PRODUCT CHANGE NOTIFICATION

| Pro | Product hierarchy no. * | | | Part no. | SBU | Type / Description | Customer part no. |
|-----|-------------------------|-----|------------|----------------|-------------------|--------------------|-------------------|
| 02 | 005 | 016 | 0000001115 | See list below | Power Entry Modul | KD Bowdenzug | |

V-Lock cord retaining feature as standard.

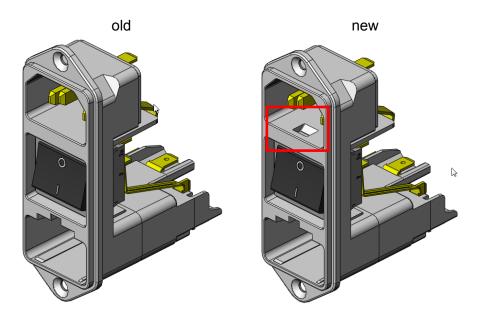
V-Lock feature integrated as standard (not an option anymore)

Form: Yes C14 inlet with V-Lock notch as standard Fit: No There are no dimensional changes

As the V-Lock is now a standard feature, the material numbers with index .21 are obsolete and will be replaced by the standard number:
